WACONIA PLANNING COMMISSION MEETING AGENDA

Thursday, March 3, 2022
6:30 PM

- 1) [SITE PLAN & DESIGN REVIEW - Darabi Dermatology - submitted by Stephen Paetzel, Mohagen Hansen Architectural Group](#)

- 2) [DESIGN REVIEW- 125 1st Street West](#)

SITE PLAN

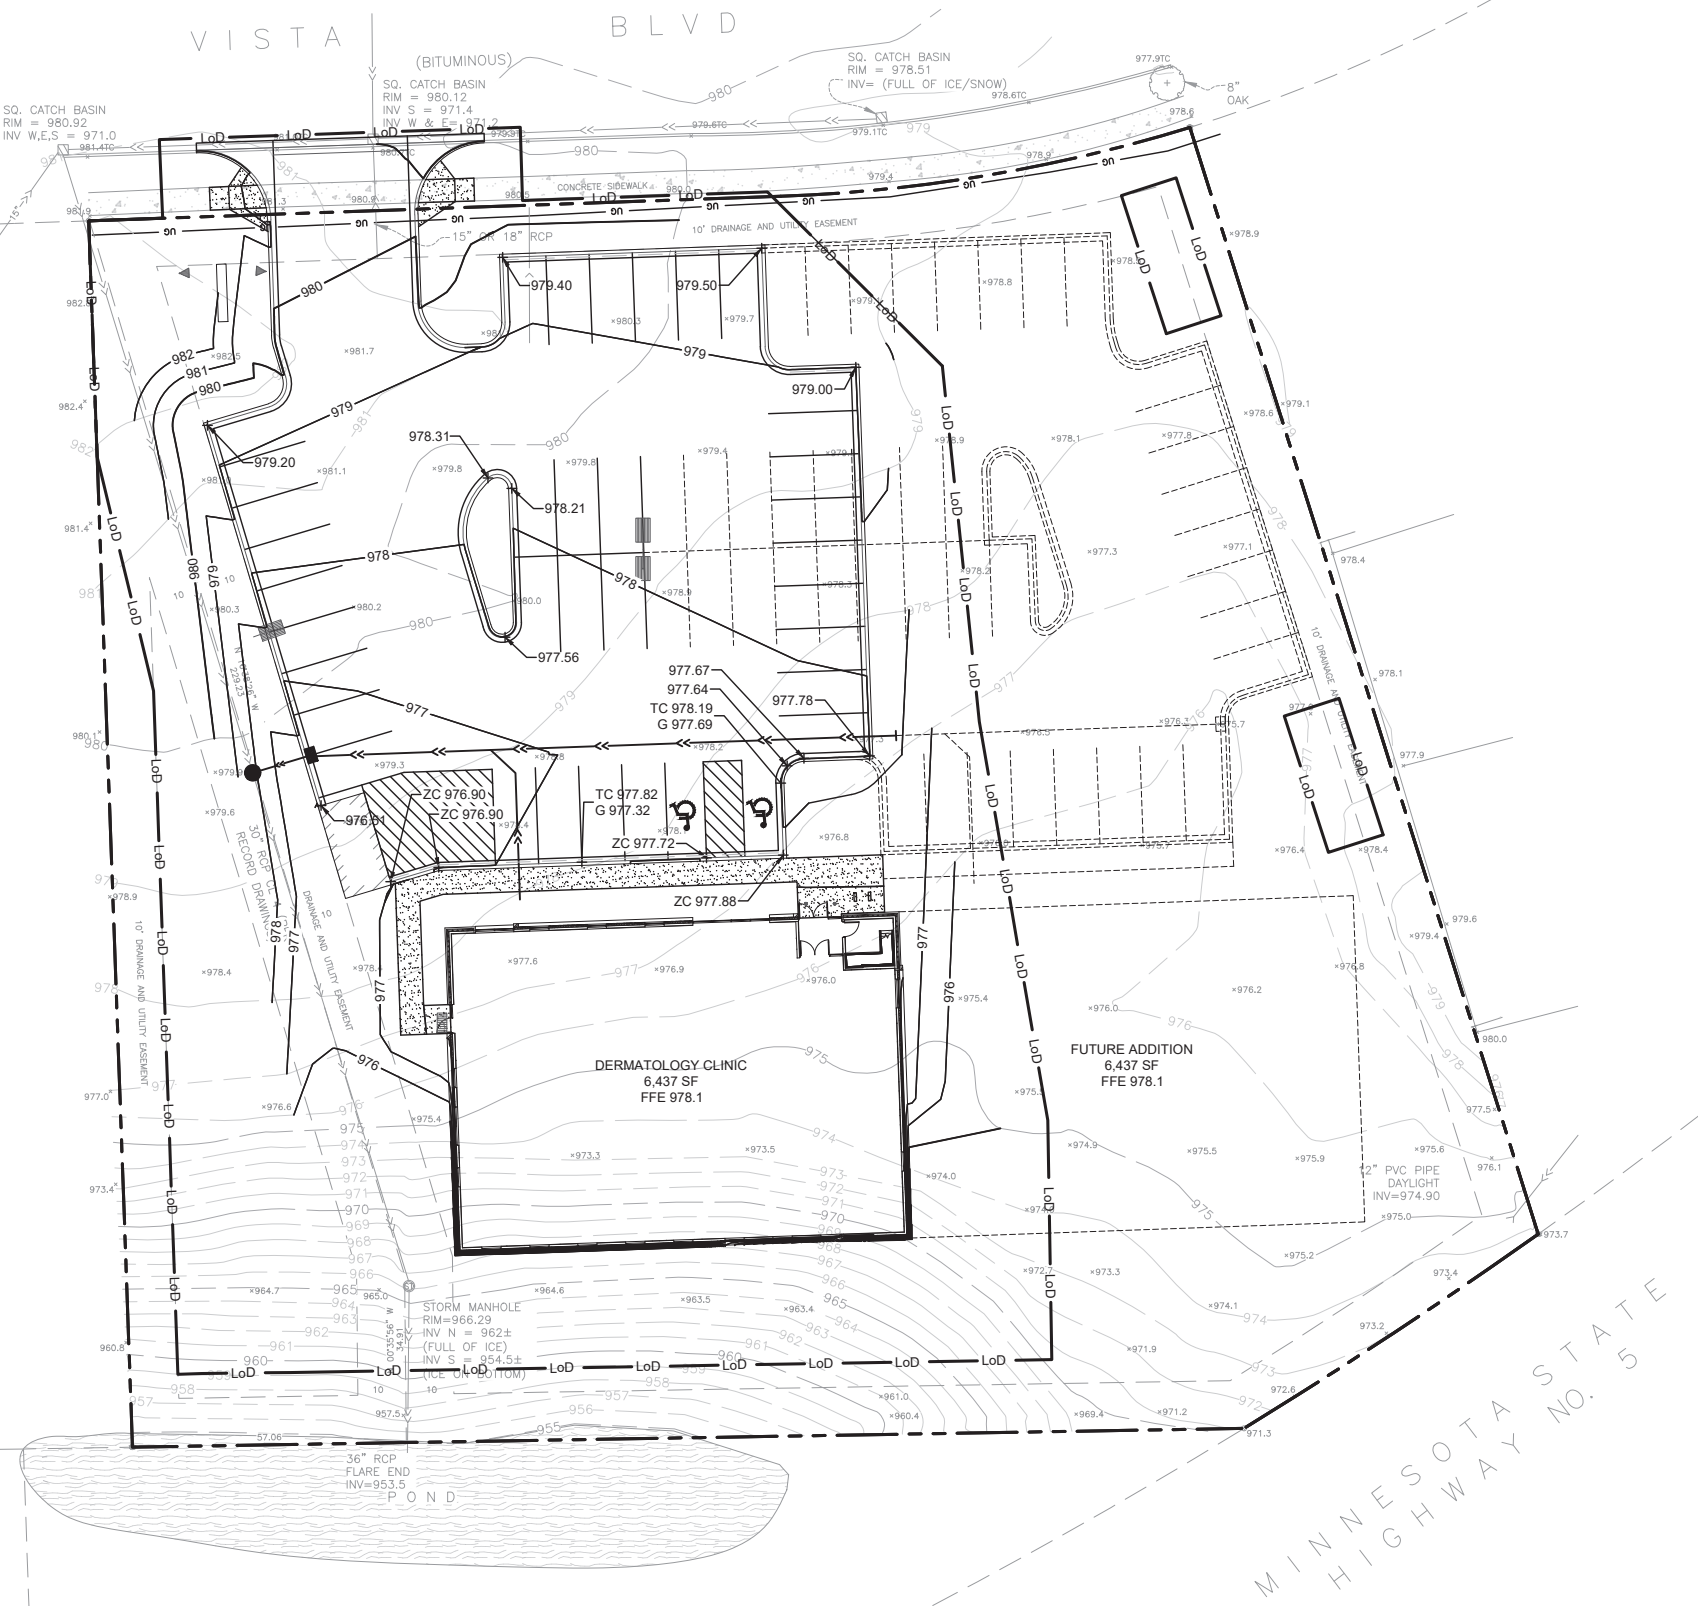
Staff notes the majority of parking spaces appear to conform to the code requirement listed above, however certain spaces appear to be less than the minimum width requirement. The applicant shall revise to meet City code requirements.

11. The City will order and install the stop sign for the exit and invoice the applicant for time and materials.
12. All off-street parking spaces shall be no less than 9 feet in width and 20 feet in length, exclusive of access drives. All parking spaces shall be clearly marked. Minimum aisle width will be dependent upon the angle of the parking stall: 90 degree angle = 24 feet aisle width; 60 degree angle = 18 feet aisle width; 45 degree angle = 13 feet aisle width; 30 degree angle = 10 feet aisle width.
13. Rear yard structure minimum setback is 20 ft. not 15 ft. as noted on the Site Plan C300

UTILITY PLAN

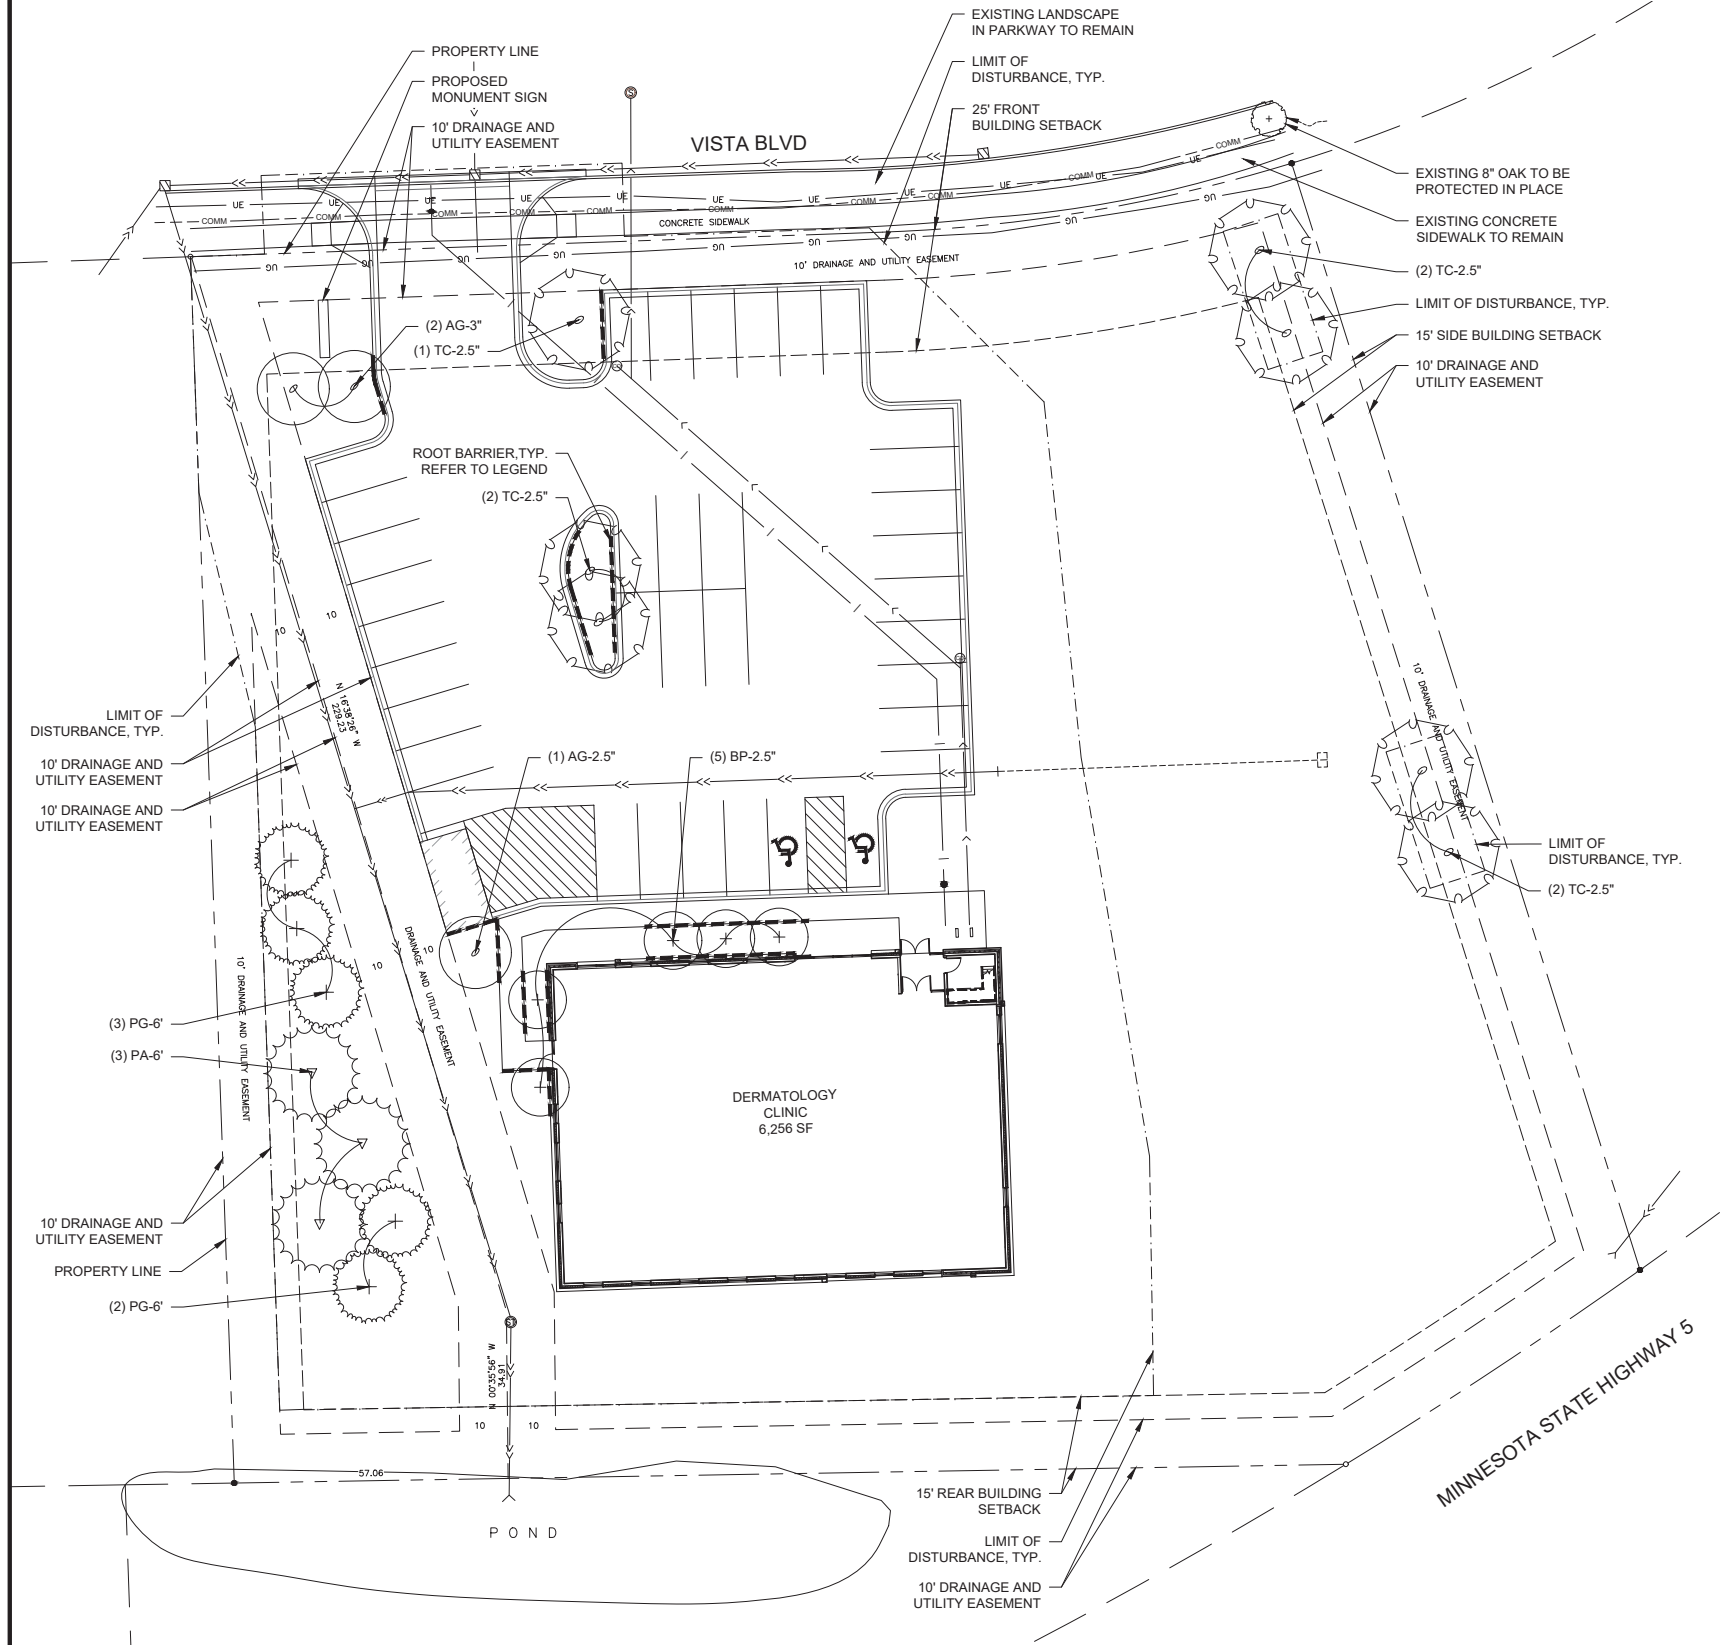
15. Sanitary sewer, watermain and storm sewer pipe materials shall be indicated on the plan.
16. To maintain cleaning velocity the slope of the sanitary sewer pipe shall be increased to a minimum of 1.0% (2.0% preferred). If additional depth is needed at the building requiring flatter grades, the sewer pipe between the proposed manholes can also be increased to 8-inch diameter.

17. A hydrant is required near the building, preferably in the green space near the front entrance.
18. Hydrants must be Waterous Improved Pacer Style, Model WB-67, with safety flange and stem coupling, or approved equal. Notes should be revised accordingly.

19. All exposed gate valve bolts shall be 304 stainless steel, and all watermain bolts shall be "Cor Blue T-Bolts" or approved equal. Notes should be revised accordingly.

Bode Gray's - Proposed Street Facade

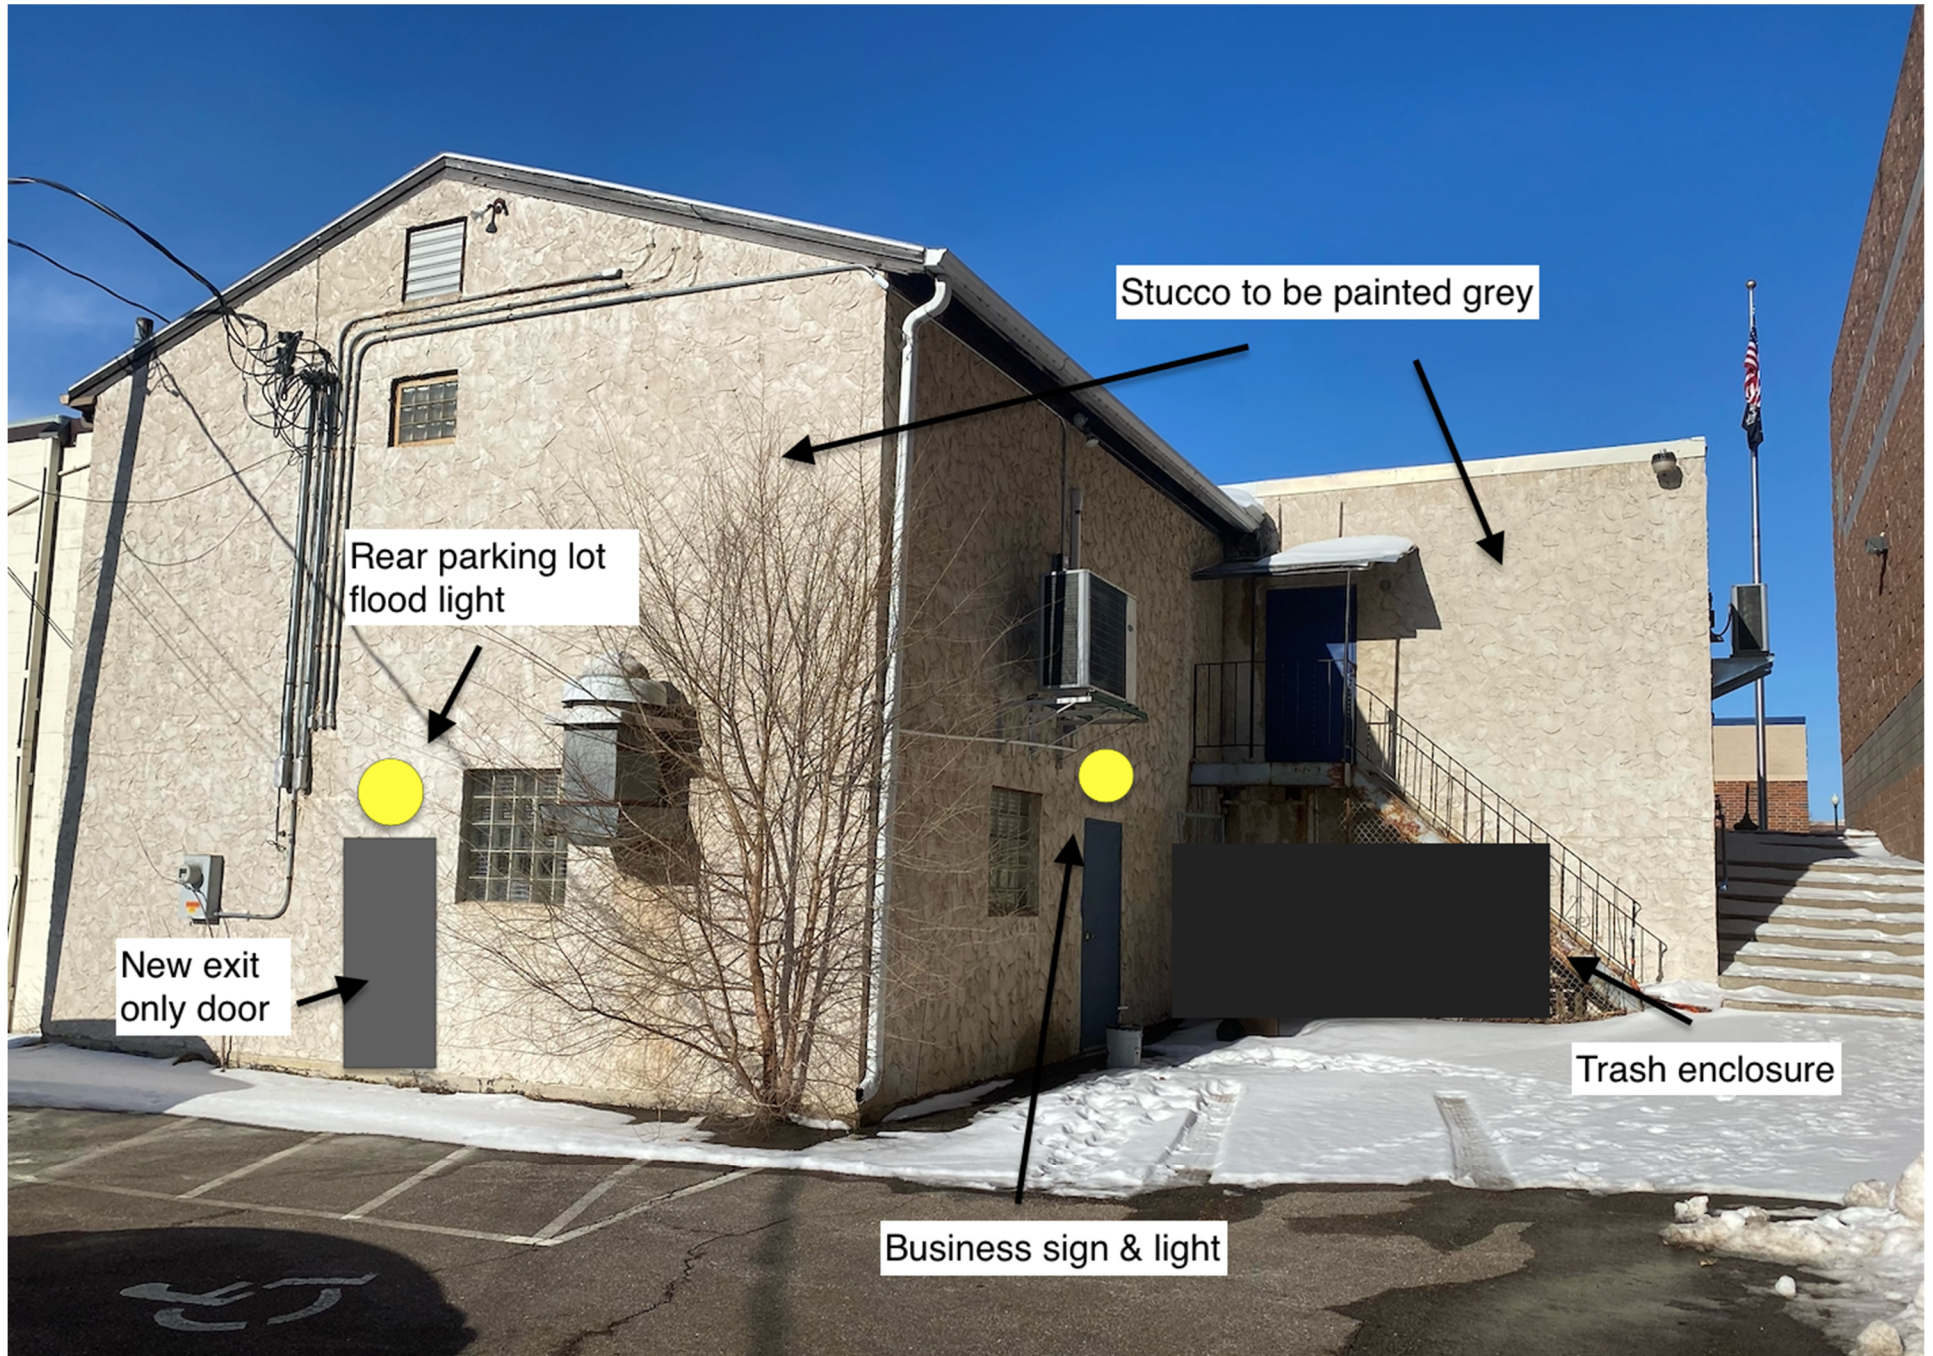
2. The improvements include painting the brick and the stucco gray, removal of the existing false front, and installation of a horizontal wood siding material. One elevation shows vertical siding which is not allowed in the downtown district, but the applicant has provided an additional image with horizontal wood siding, and this is the option they are planning for with improvement of the front façade, which conforms to City Code.

4. The proposed signage requires some modification to be compliant with City Code requirements. City Code allows one wall sign per building face not to exceed 10% of said building face. The front façade indicates two signs, which requires revision, as does the east side of the building. The sign details provided appear to be consistent with location, color, etc. The final sign plan shall be reviewed and approved by staff upon submittal of a sign permit application.

4. The signage shall be revised consistent with the design standards and Section 900.10 of the City Code. The signage shall require a sign permit from the City prior to ordering or installation.
